NRDC Input on ENERGY STAR Draft 2 Version 8.0 Specification for Televisions

May 19, 2017

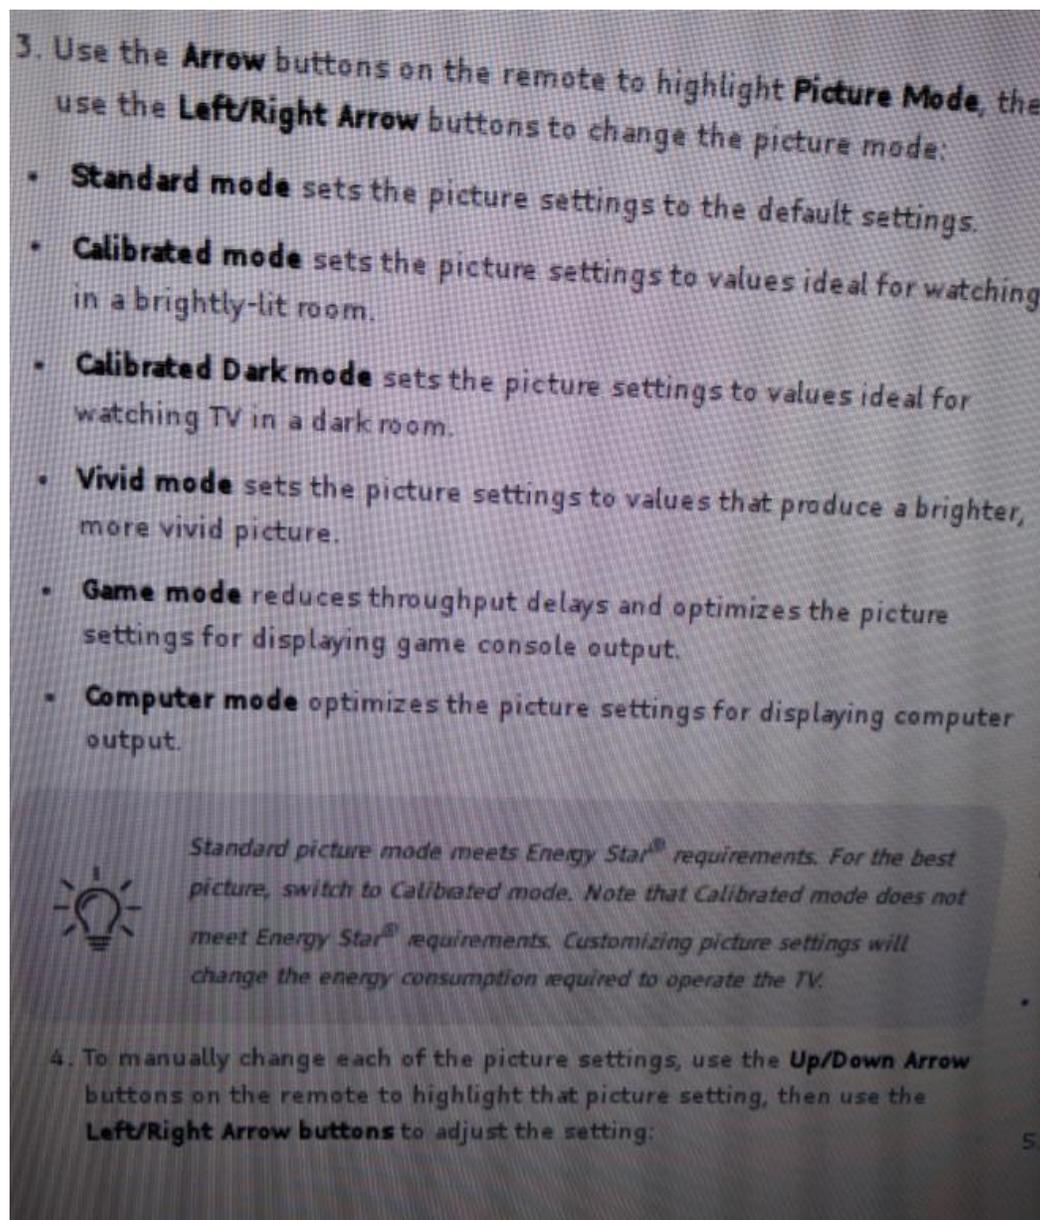
Recently we came across a new TV that encouraged users to select the calibrated picture setting. When we selected this setting, the ABC feature which was enabled by default, was automatically turned off. In digging through the manual we learned that the calibrated setting set the TV to values that were ideal for viewing in a bright room. When calibrated was selected the TV's backlight jumped to 100, its brightest possible level, and ABC was automatically disabled.

This implementation is troubling as this TV is always operated in this higher power consuming state even though it might not always be viewed in a bright room. (Note, unless the consumer took the time to access and scroll through the user manual, they would not have known that calibrated was designed for bright room viewing.) The benefits of this TV's energy saving feature are essentially negated in this case.

A well designed TV with ABC would sense the light levels in the room and would adjust the TV backlight levels accordingly – make it brighter when ambient light levels are observed and dimmer for low ambient light levels.

Barring receipt of compelling information that demonstrates why these energy saving features need to be disabled when a certain picture setting is selected, we strongly encourage EPA to remove its allowance for these energy saving features to be automatically disabled. (As we stated previously, the consumer can at any time choose to disable the energy saving feature at a later time. The only caveat being that the TV shall not at any time prompt the user to disable these energy saving features or to change the picture setting from its default setting. If this is the case, then the TV must be tested with the energy saving feature disabled or in the most power consumptive picture setting.) The last thing EPA wants to do is to allow a TV to ship with energy saving features enabled as a means to receive a very low energy score and receive an unfair competitive advantage, and have a few very enticing presets with names such as "Best Picture" or "Preferred" whereby the energy savings features are automatically disabled and annual energy use of ENERGY STAR labelled TVs skyrockets.
